BV1 (M-Note) SYSTEM BLOCK DIAGRAM

PROJECT : BV1
Quanta Computer Inc.

Revision History

BV1 / M-Note Schematic EC Tracking Record A (for DV --> SIV) Dec. 28, 2004

Size	Document Number	Alviso Host(1/5)	Rev
Custom	Date: Thursday, October 06, 2005		Sheet 4 of 73

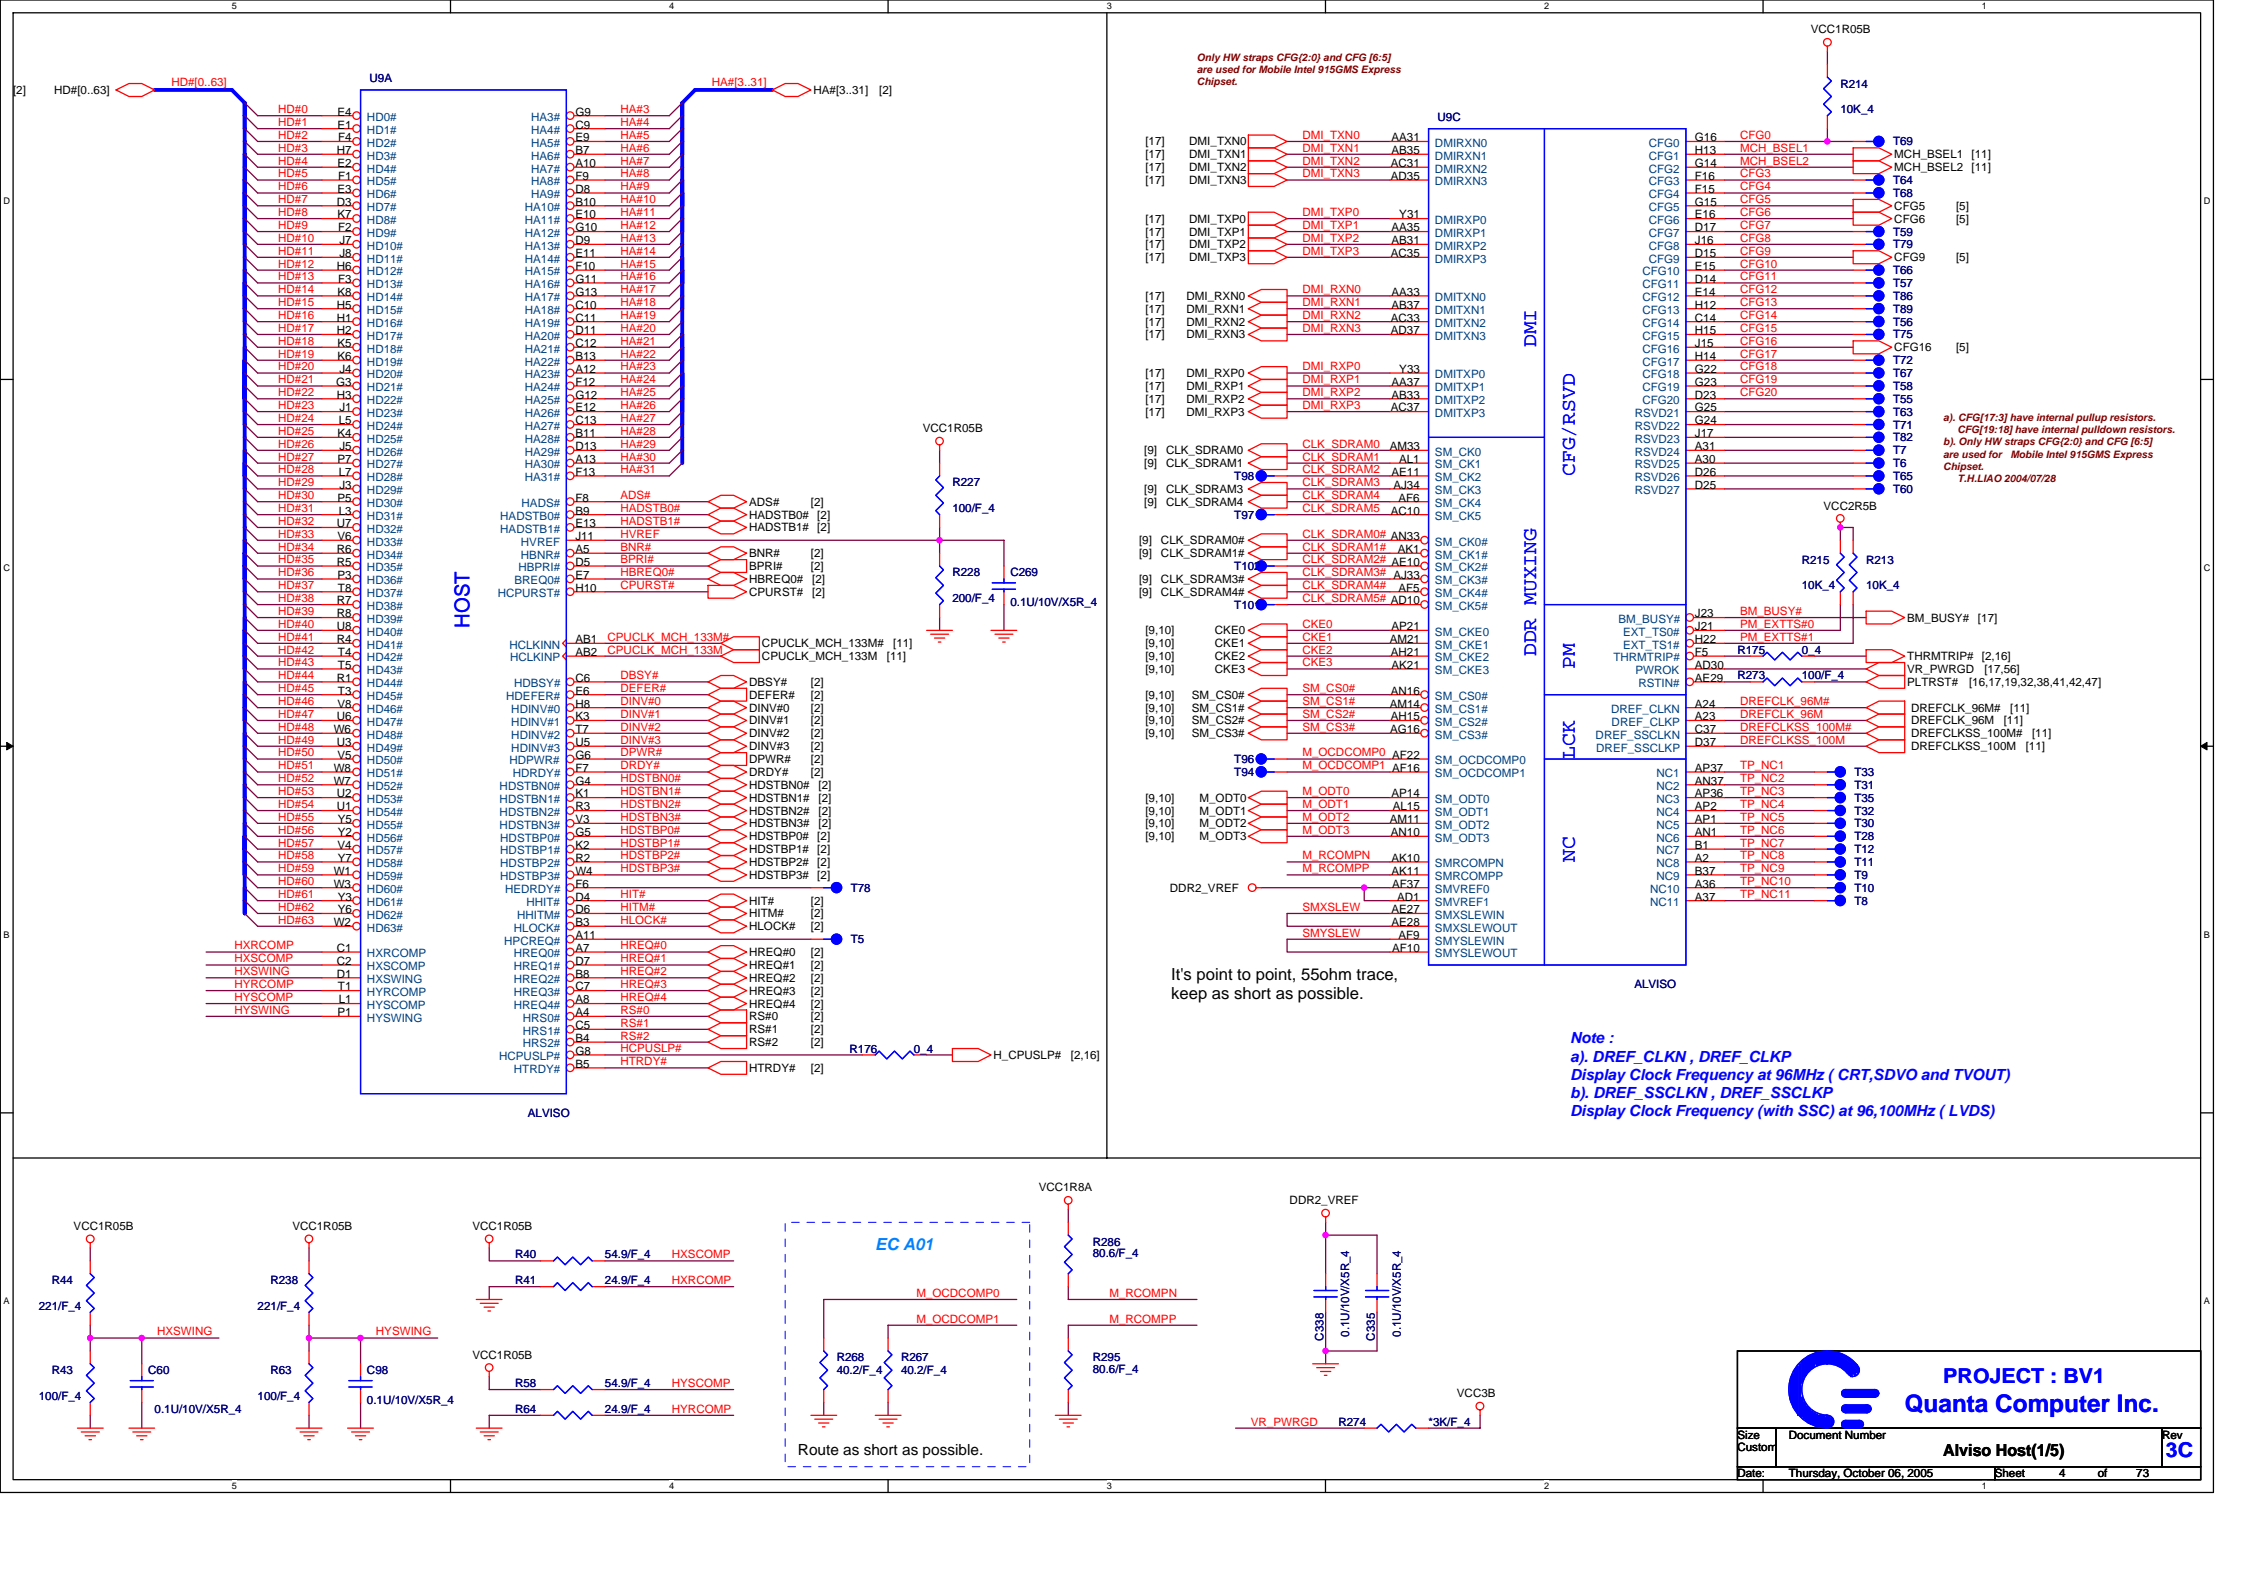
- EC A01/04/ Change R268,R267 from NO ASM to ASM 40.2 ohm 1% because the SMVREF[1:0] voltage will droop below specification 200uA (Intel plan fix in C1 stepping).

- EC A53/04/ Change L35 filter bead from BLM18PG181SN1 to inductor 1uH.
- EC A54/04/ Change L34 filter bead from BLM18PG181SN1 to inductor 91nH.
- EC A55/04/ Change L19 inductor from 10uH to 1uH.

Size: Custom | Document Number: CLOCK GENERATOR | Rev: 3C
 Date: Thursday, October 06, 2005 | Sheet: 11 of 73

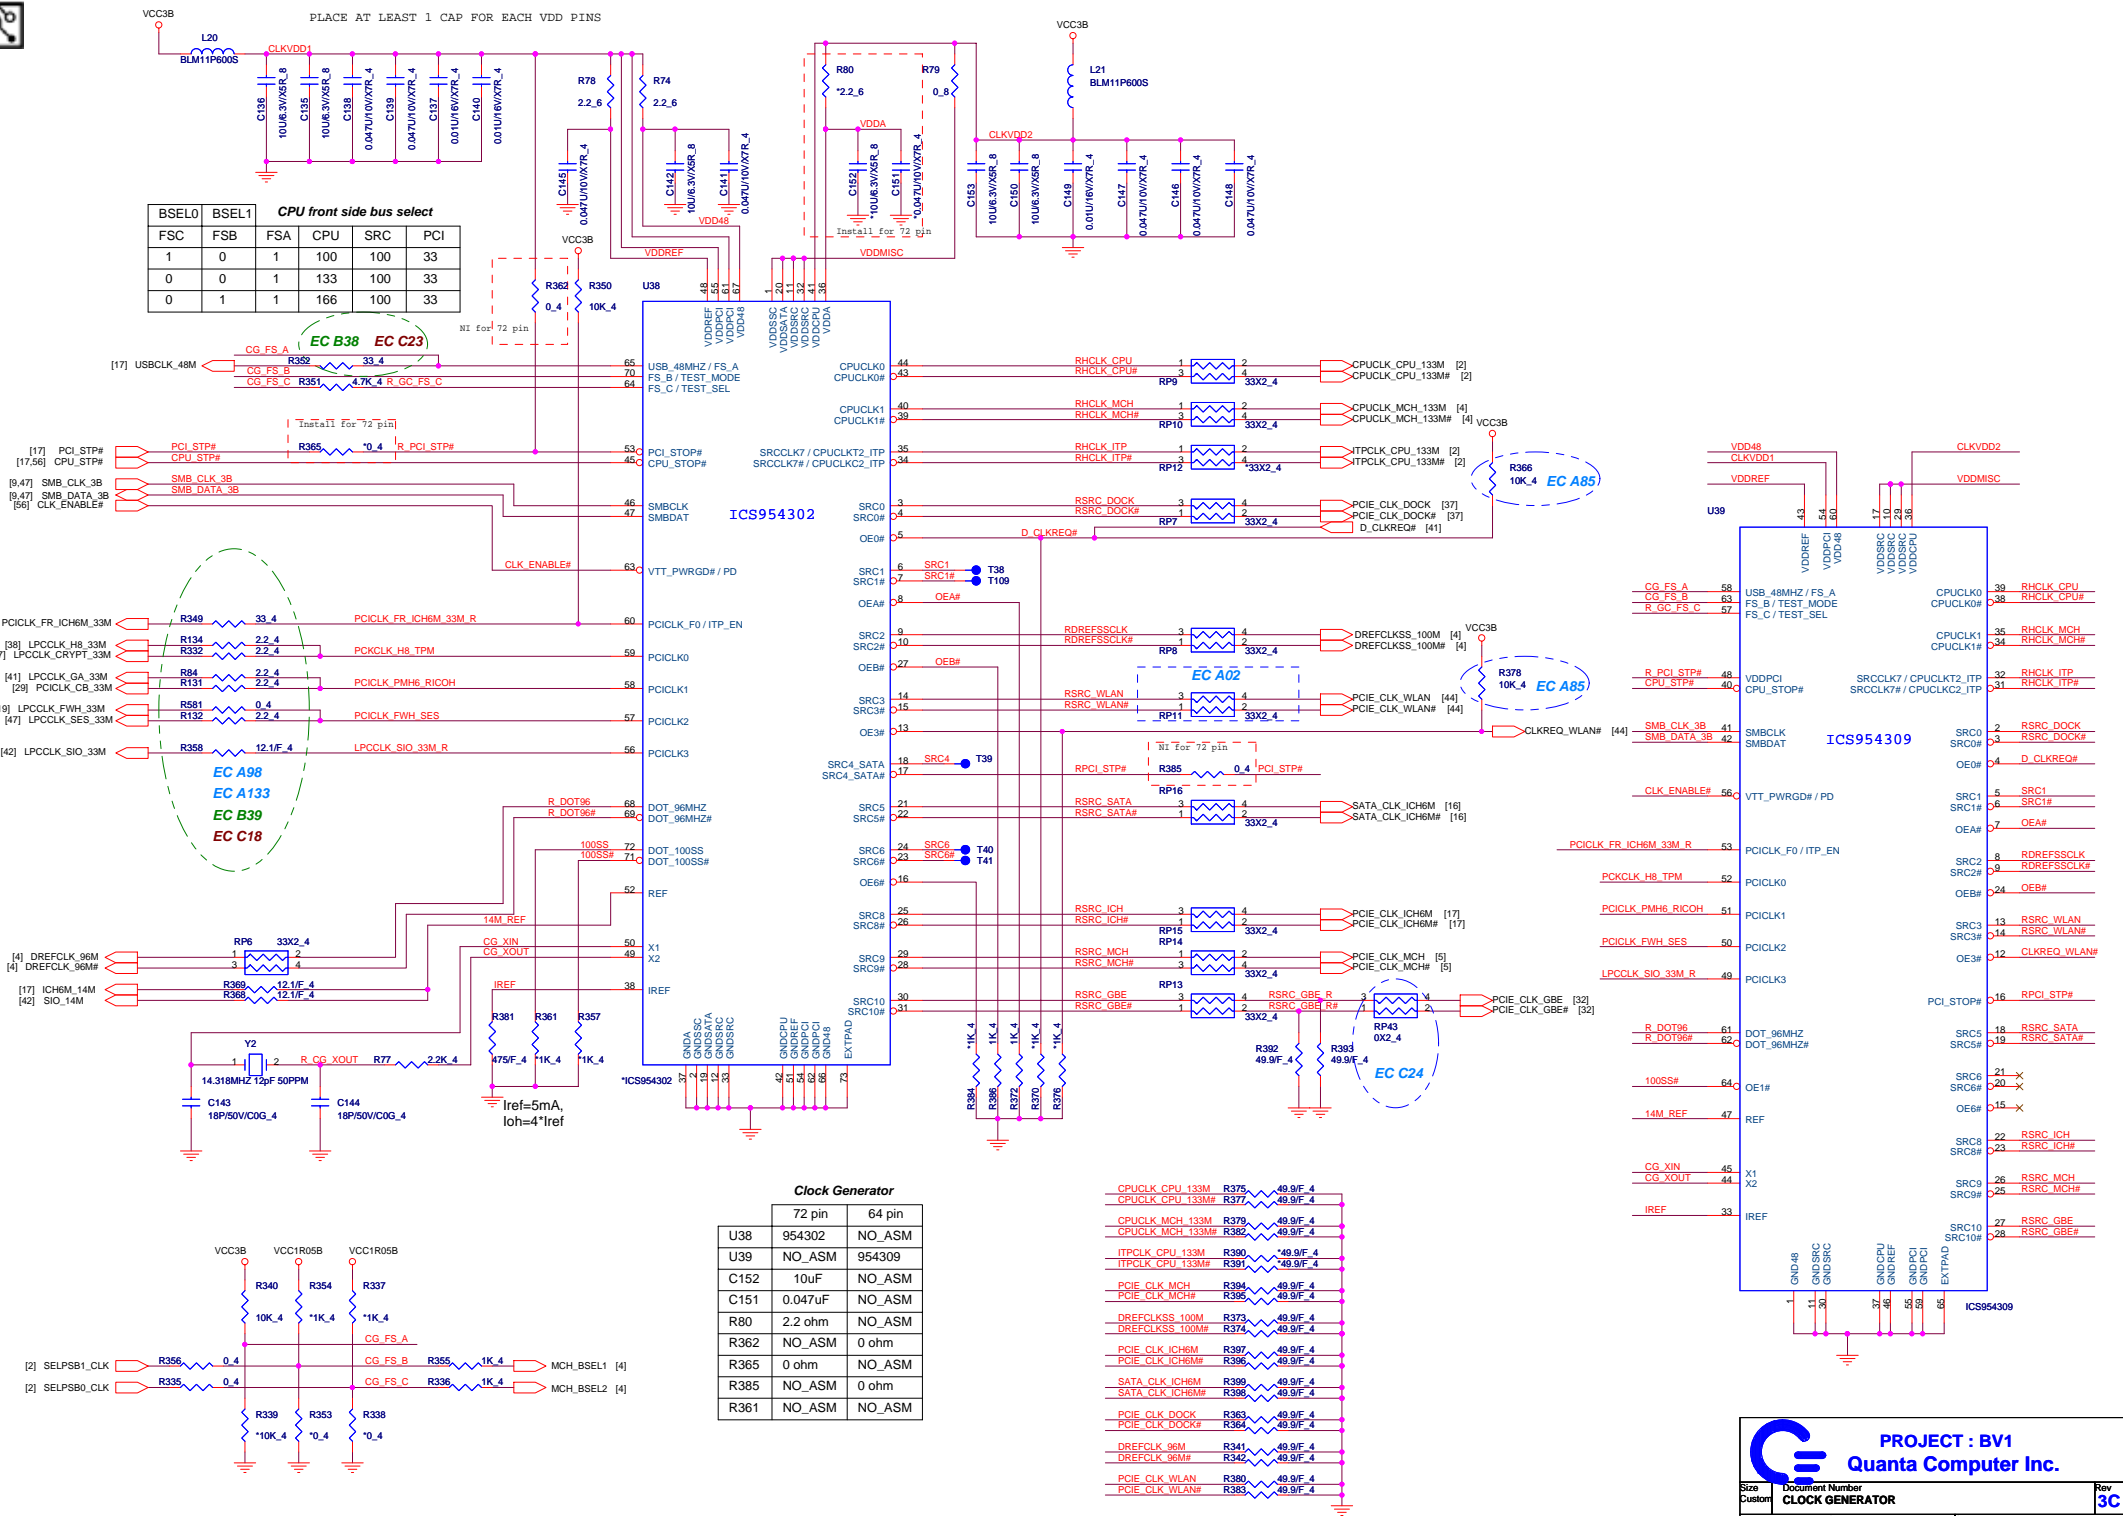
- EC A02/11/ Add RP11 33ohm 4P2R resistor to ASM , the reason is for MINI-PCIE clock use.
- EC A03/16/ Change Y6 32.768Khz crystal pin definition because it's different with layout footprint.

- EC A97/50/ Modify pin_CSSN to support Docking System.
- EC A98/11/ Modify clock gen driven buffer.
- EC A99/28/ Change PCMCIA connector vendor.
- EC A100/38/ Delete R84 resistor pad,it's un-necessary pull-up.

- EC A130/62/ Change PC115 to NOASM.
- EC A131/37/ Change F3 to NANOSMDC050F.
- EC A132/28/ Change R443 to 10 ohm.
- EC A133/11/ Change R358, R84, R131, R132, R581 to 12.1 ohm 1%.

- EC B37/35/ Change C133,C134 from 470pF to 1000pF and C607,C608 to ASM for EMI request.
- EC B38/11/ Change R352 from 33 ohm to 75 ohm for 48 Mhz slew rate fail issue.

- EC B39/11/ Change PCICLK 33MHz circuit for signal quality.
- EC B40/19/ Remove G2 short pad for IBM request.
- EC B41/49/ Correct G-sensor STMicro table as same as ADI.

- EC C17/50/52/ Add cap according to EMI request.
- EC C18/11/ Change PCICLK 33MHz damping for signal quality.
- EC C19/23/ Pull down preparation (No ASM) on ACZ_RST# pin on code side (SVT-IBM-17)

- EC C23/11/ Change R352 value from 75ohm to 33ohm for USB 48MHz

Size Custom	Document Number	GBE BCM5751M(1/2)	Rev 3C
Date:	Thursday, October 06, 2005	Sheet	32 of 73

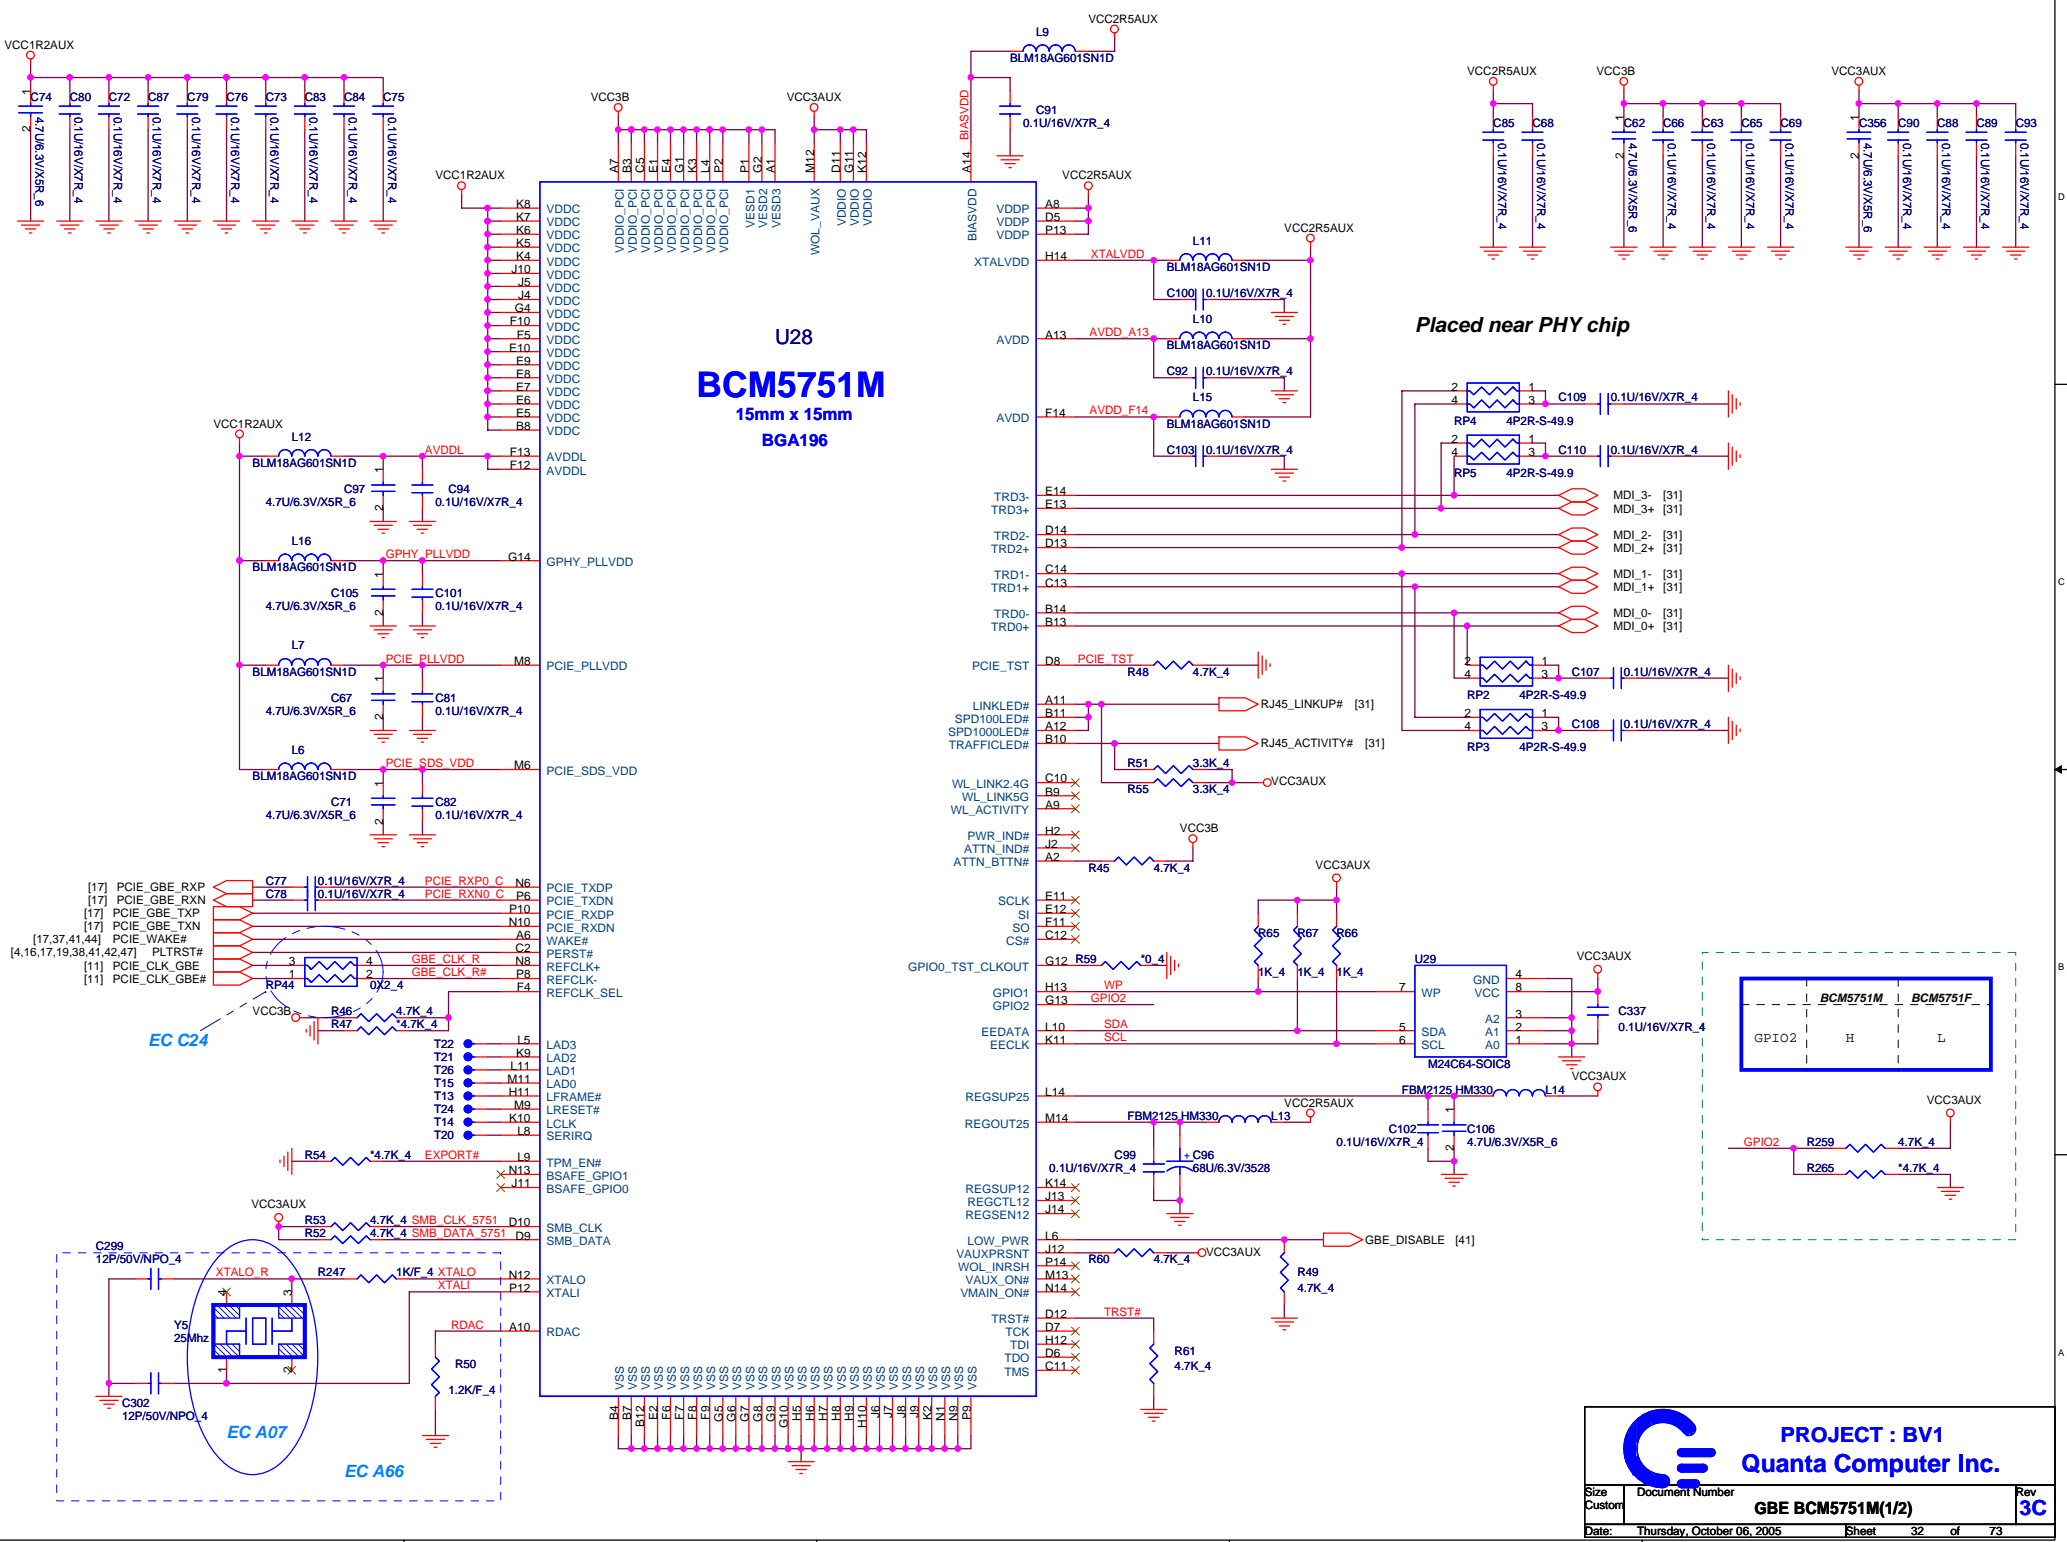
- EC A07/32/ Change Y5 25Mhz crystal pin definition because it's different with layout footprint.
- EC A08/38/ Change R84,R95,R94,R454,R85 to NO ASM. Because these resistors was double side pull high.

- EC A66/32/ Change value of R247,R50,C299,C302 for IEEE lan measurement.
- EC A67/08/ Add decouping capacitor of alviso power pin.
- EC A68/25/ Change headphone selection circuit. (SIV-IBM-29)
